SPECIAL BOARD MEETING

March 25, 2019

Subject 6.4 Approval of Corrected Change Order for RAN Enterprises

(COR) CHANGE ORDER REQUEST # 10R2

| Rio Steam K-8 | | | | |
|------------------|--------------------------------|---------------------|---|--|
| MPR E110 LP31 | 3 Grille Identification: M2.51 | | *************************************** | |

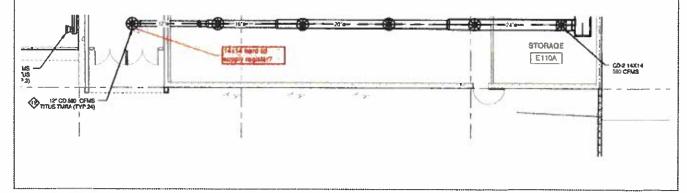
Please reference Mechanical Sheet M2.51 MPR E110 and LP3B (small room across from the Storage E110 A inside MPR). The plans are calling for "12" CD 580 CFMS TiTUS TMRA (Typ. 24)" exposed supply registers to serve the MPR E110 and the two rooms E110A and LP3B.

Please note that the Storage E110A and the room across from that LP3B are both hard lids rooms and would therefore both have to be CD-2 14x14. Currently only the grille in Storage E110 A is identified as a hard lid grille, while the grille in LP3B is identified as exposed grille.

Building "E" Reference Sheet M2.51 RFI-0378R1 RAN39

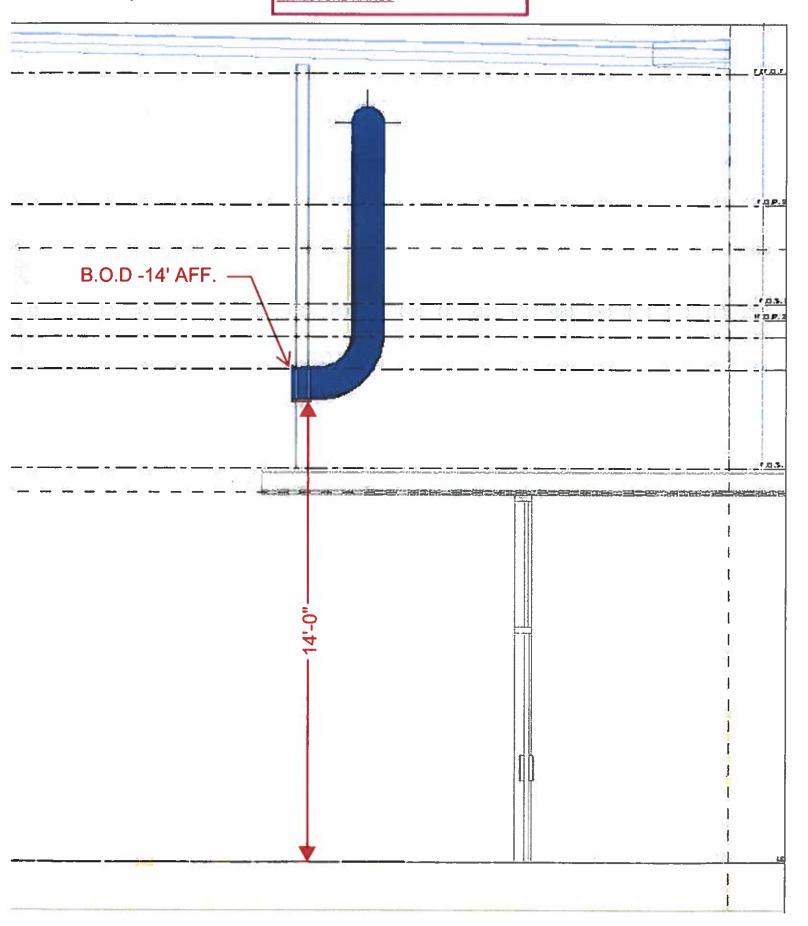
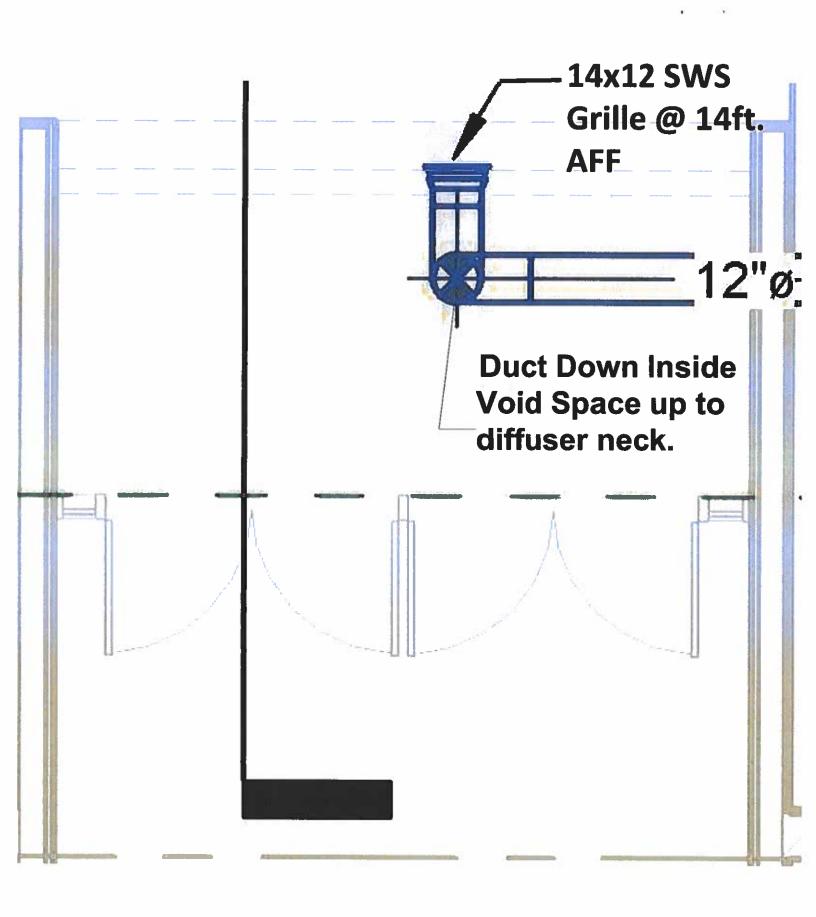
The District's response to RFI #39 (District RFI #378) does not provide the complete information required for the installation to proceed.

Please confirm the bottom height of the 14x12 SWS-1 grille that will be provided per the response.

Please reference Mechanical Sheet M2.51 MPR E110 and LP3B (small room across from the Storage E110 A inside MPR). The plans are calling for "12" CD 580 CFMS TITUS TMRA (Typ. 24)" exposed supply registers to serve the MPR E110 and the two rooms E110A and LP3B.

Response 1: Refer to attached Sketch SKM-378.1 for the revised diffuser location. Provide 14x12 SWS-1@580CFM.

Response 2: We are confirming that there are quantity 22 - 12" CD 580 CFMS TMRA or Equal grille (Exposed Supply Grilles). QTY-1 14x14 CD-2 for storage E110A and QTY-1 14x12 SWS-1@580CFMS.

| Rio Steam K-8 | | | |
|------------------|------------------------------|---------------------|------|
| MPR E110 LP31 | Grille Identification: M2.51 | | |

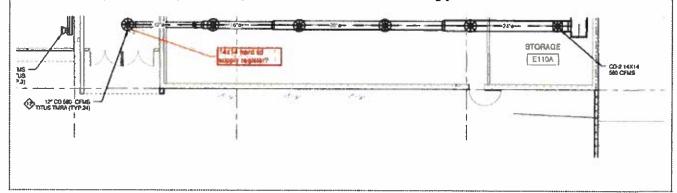
Please reference Mechanical Sheet M2.51 MPR E110 and LP3B (small room across from the Storage E110 A inside MPR). The plans are calling for "12" CD 580 CFMS TITUS TMRA (Typ. 24)" exposed supply registers to serve the MPR E110 and the two rooms E110A and LP3B.

Please note that the Storage E110A and the room across from that LP3B are both hard lids rooms and would therefore both have to be CD-2 14x14. Currently only the grille in Storage E110 A is identified as a hard lid grille, while the grille in LP3B is identified as exposed grille.

Building "E" Reference Sheet M2.51 RFI-0378R1 RAN39

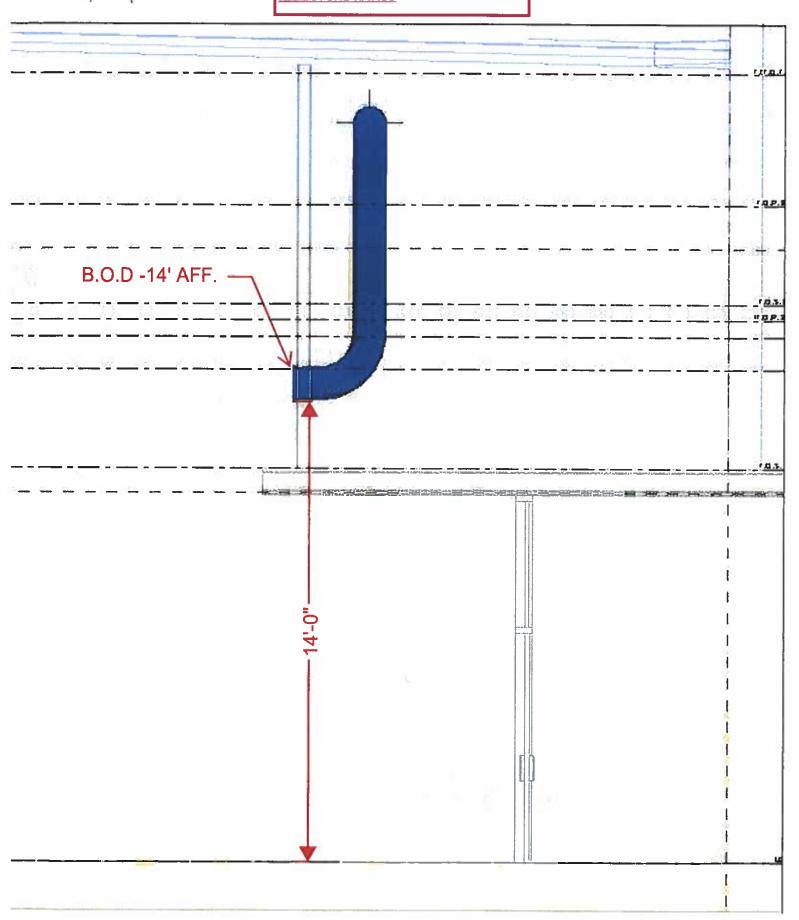
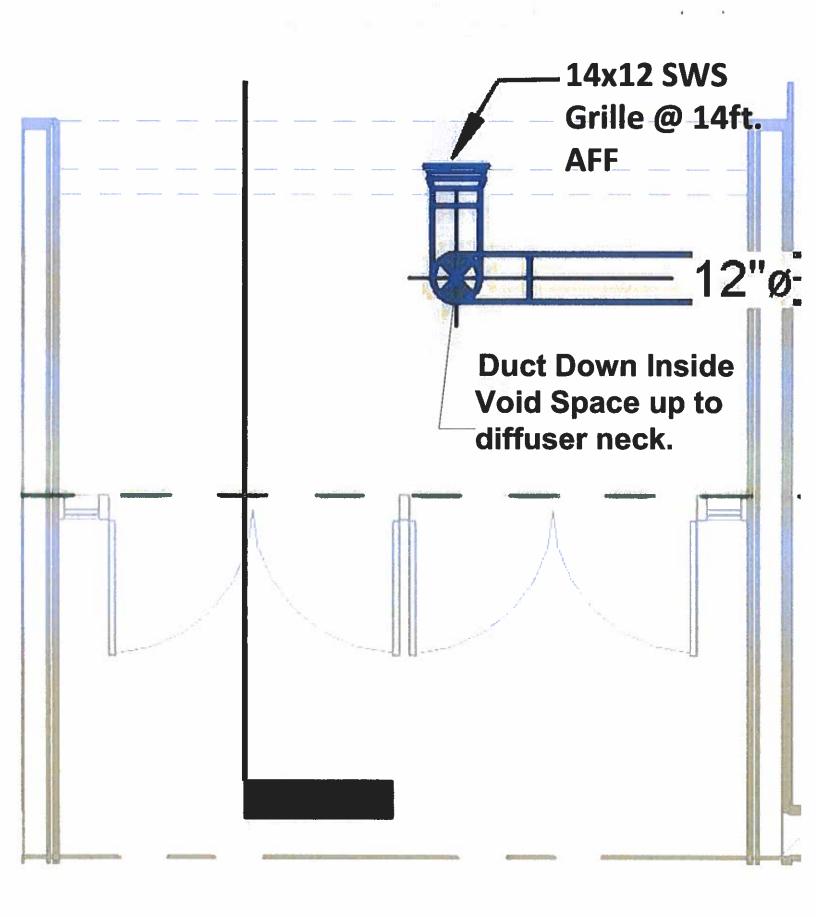
The District's response to RFI #39 (District RFI #378) does not provide the complete Information required for the installation to proceed.

Please reference Mechanical Sheet M2.51 MPR E110 and LP3B (small room across from the Storage E110 A inside MPR). The plans are calling for "12" CD 580 CFMS TITUS TMRA (Typ. 24)" exposed supply registers to serve the MPR E110 and the two rooms E110A and LP3B.

Response 1: Refer to attached Sketch SKM-378.1 for the revised diffuser location. Provide 14x12 SWS-1@580CFM.
